*Superconducting Super Collider Laboratory
2550 Beckleymeade Avenue, Suite 240
Dallas, TX 75237-3946*

Magnet Systems Division

MEMORANDUM

Subject: BNL-FNAL CDM Compatibility

FIGURE 1

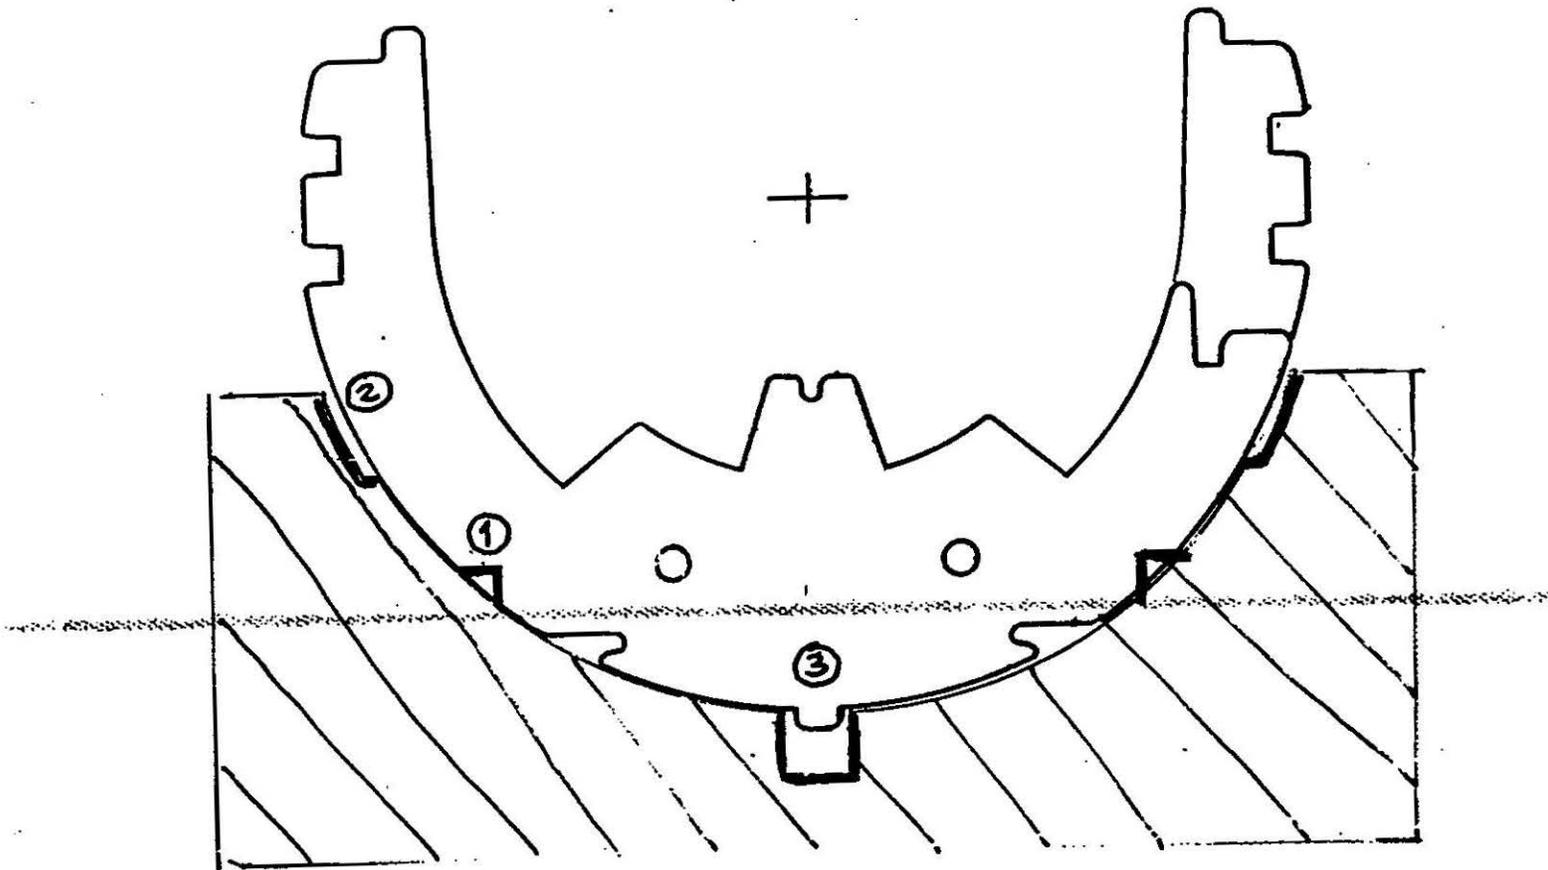
1. Collaring: The first two 50mm long magnets are planned to be collared at BNL on the new production type collaring press. After that, any subsequent magnets required for the string test could also be collared the same way with industrial participation. It was felt there is some compromise to the design if the BNL collars were to be altered to fit the FNAL collaring tooling (See Figure 1). Thus, it was recommended that FNAL proceed to obtain dies for the upper and lower collaring press laminations that would exactly match the BNL collar. The laminations would be made into tooling sections which could be assembled into the FNAL press frame to permit collaring of the BNL design collar. (Phil Sanger will look into the question of the die procurement.)

BNL COLLAR INTO FINAL PRESS.OBSTACLES

- ① INTERFERENCE OF ALIGNMENT TABS.
- ② CUTOUT FOR FINAL COLLAR REDUCES LATERAL SUPPORT OF BNL COLLAR ; COULD CAUSE YIELDING AT ASSY.
- ③ PRECISE ALIGNMENT REQUIRED AT VERTICAL TAB OF BNL COLLAR MUST BE ACHIEVED BY CUSTOM FITTING INSERT INTO LOOSELY TOLERANCED (± 0.010) KEYWAY.
